TRANS/WP.29/GRE/2001/8
19 February, 2001

World Forum for Harmonisation of Vehicle Regulations (WP.29)

Working Party on Lighting and Light-Signalling (GRE)
(Forty-sixth session, 27-30 March, agenda item 2.8)

PROPOSAL FOR DRAFT SUPPLEMENT 1 TO THE DRAFT REGULATION:

OVERVIEW OF OPERATIONAL PERIODS
CONCERNING TEST FOR STABILITY OF PHOTOMETRIC PERFORMANCE

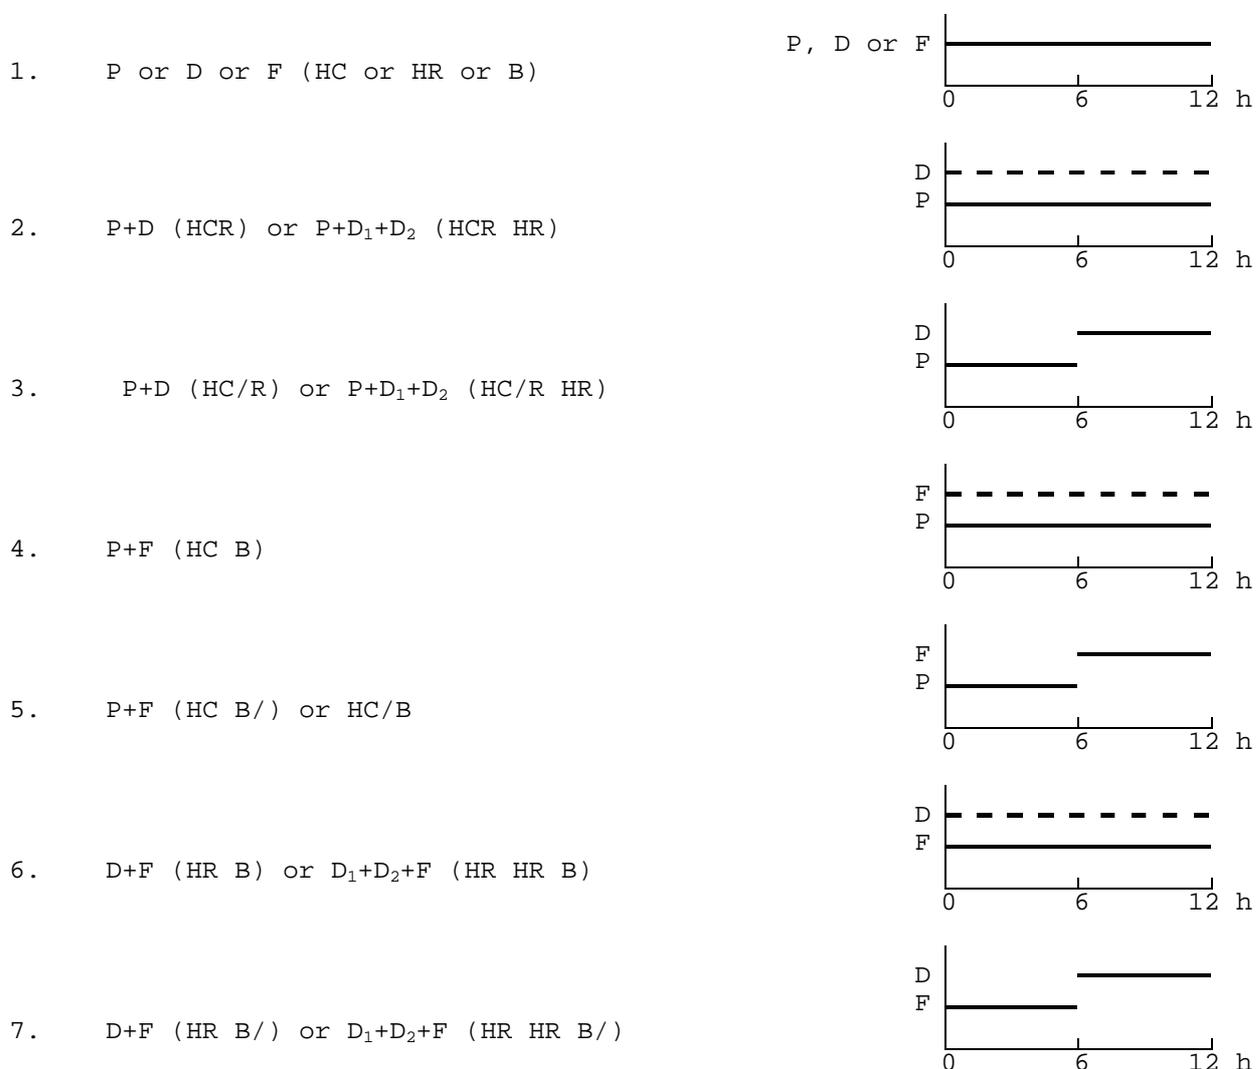
Add a new Annex 8, to read:

Abbreviations: P: passing beam lamp
D: driving beam lamp (D₁ + D₂ means two driving beams)
F: front fog lamp
- - - - - : means a cycle of 15 minutes off and 5 minutes lit.

All following grouped headlamps and front fog lamps together with the added marking symbols are given as examples and are not exhaustive.

8. P+D+F (HCR B) or P+D₁+D₂+F (HCR HR B)

9. P+D+F (HC/R B) or P+D₁+D₂+F (HC/R HR B)

10. P+D+F (HCR B/) or P+D₁+D₂+F (HCR HR B/)

11. P+D+F (HC/R B/) or P+D₁+D₂+F (HC/R HR B/)
